MEMORANDUM

DATE: August 18, 2020

SUBJECT: Engineering Geologic Review of Timber Harvesting Plan 1-20-00084 SON

Date: Aug. 2020	Regional Geologic Map To Accompany Engineering Geologic Review of THP 1-20-00084 SON	Figure: 1
Scale: 1" = 1250'		
Approved By: CGS

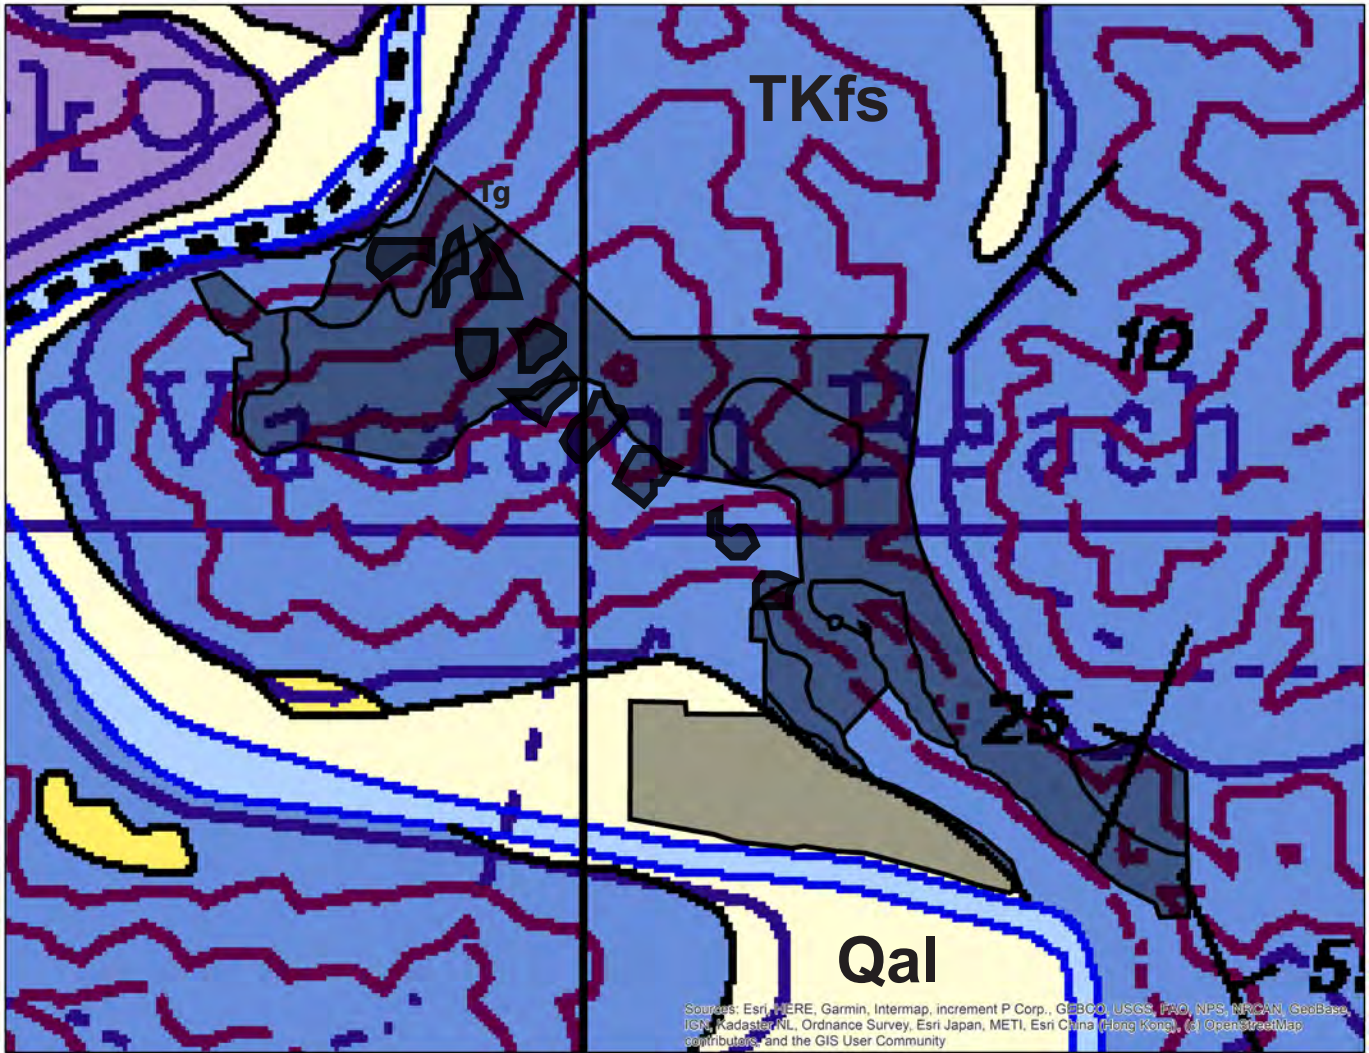
Regional geologic mapping (Blake and others, 2002. Figure 1) identifies Tertiary to Cretaceous-age Coastal or Central Belt Franciscan Formation as underlying Timber Harvest Plan 1-20-00084 SON, consistent with descriptions provided in the plan-attached geologic report (Best, 2020). The Franciscan Formation is described as massive, brown- and orange weathered, green to gray feldspathic-lithic wacke, including thin beds of sandstone, dark-gray shale and slate (Blake and others, 2002). The Franciscan Formation is overlain by Quaternary-age alluvial fan and fluvial deposits along the Russian River floodplain within the southwestern THP boundary (Blake and others, 2002). The fluvial deposits are described as brown or tan, medium dense to dense, gravelly sand or sandy gravel that generally grade upward to sandy or silty clay (Blake and others, 2002). Bedrock observed during the PHI generally consisted of brownish gray sandstone, consistent with mapping and descriptions made by Blake and others (2002) and Best (2020).

Regional Landslide Map
To Accompany
Engineering Geologic Review of
THP 1-20-00084 SON

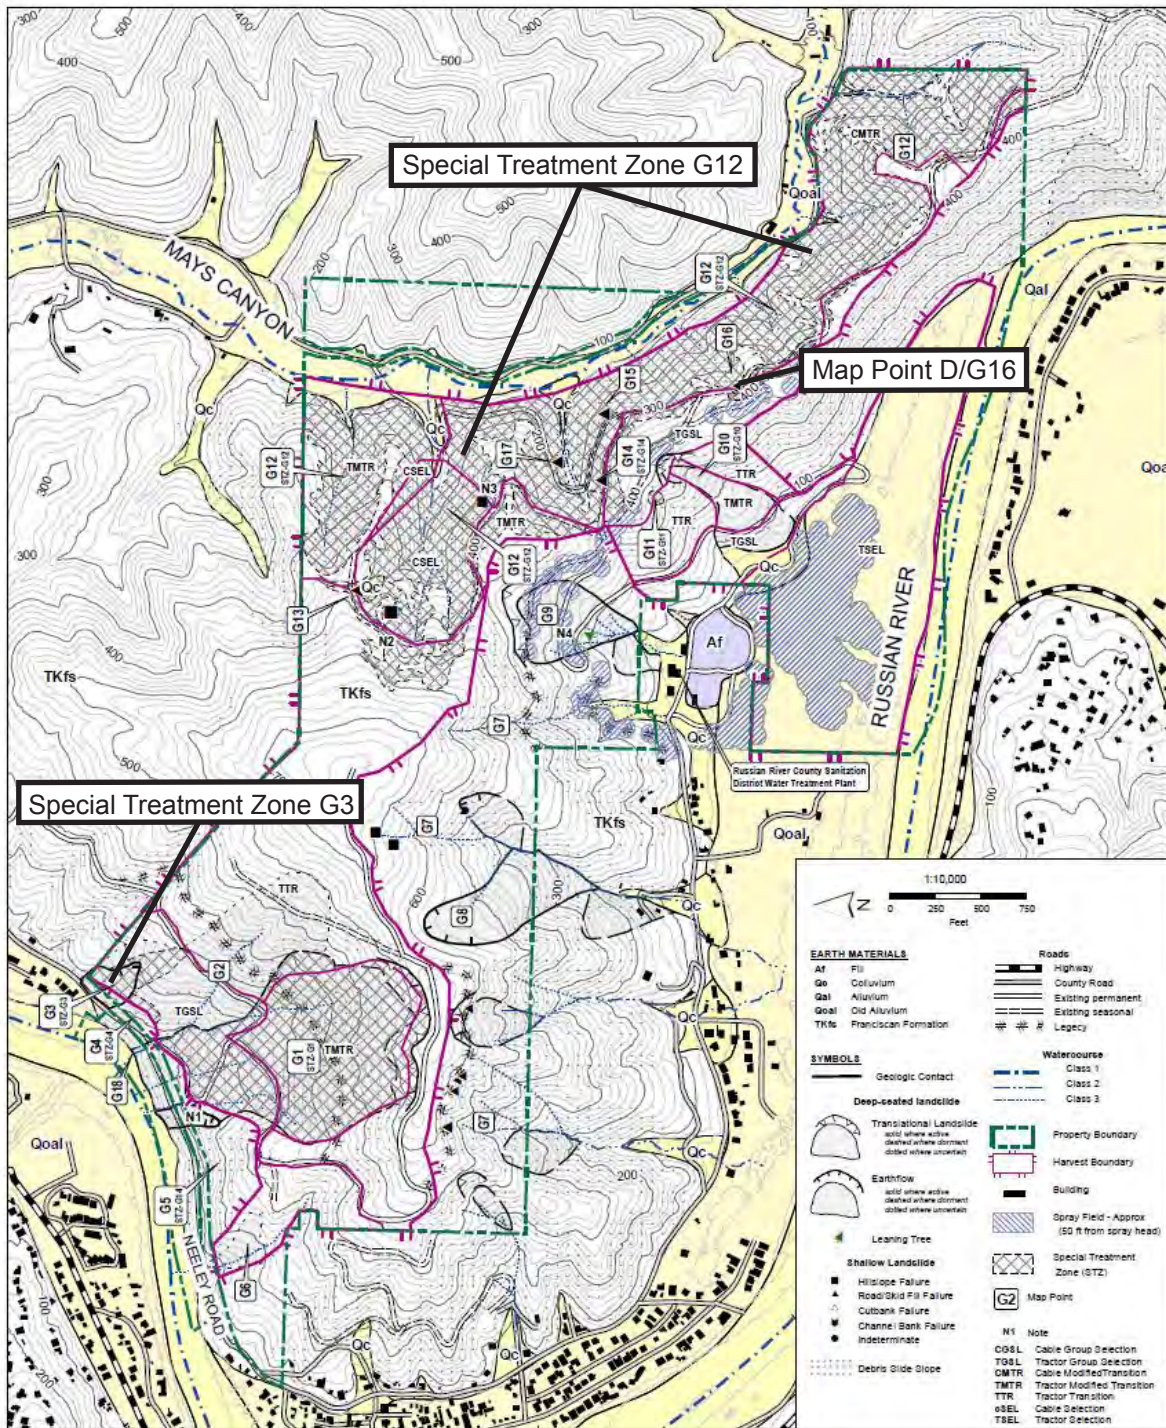
Site slopes (ranging from 40 to 70± percent gradients) drain to the southwest, northwest, northeast and east via Class II and Class III watercourses that are tributaries to Mays Canyon and the Russian River, both Class I watercourses. Regional geologic mapping (Huffman and Armstrong, 1980, Figure 2) and plan-attached site-specific mapping (Best, 2020) identify areas of shallow- and deep-seated landsliding as underlying and downslope of the proposed THP boundary. The unstable areas were visited during the PHI and are discussed below under the General Observations portion of this memo.

1). Harvesting Within Mapped Deep-Seated Landslides: Plan-attached site-specific geologic mapping (Best, 2020) identifies areas of deep-seated landsliding within and downslope of the proposed THP boundary, consistent with available regional geologic mapping (Huffman and Armstrong, 1980). Review of aerial photographs (sets 1984, 1992, 1996, 1999, Google Earth images), lidar (2014) and PHI observations generally concur with Best (2020) that the mapped deep-seated features generally appear as concave slopes tens to hundreds of feet wide and long and appear to correspond to the dormant historic to dormant-young morphological age classification of Keaton and Degraff (1996). The deep-seated landslide areas contain weathered and rounded head and lateral scarps with some evidence of localized historic activity, including hummocky and benched topography along 30 to greater than 70-percent slopes that support generally straight-standing second growth conifers.
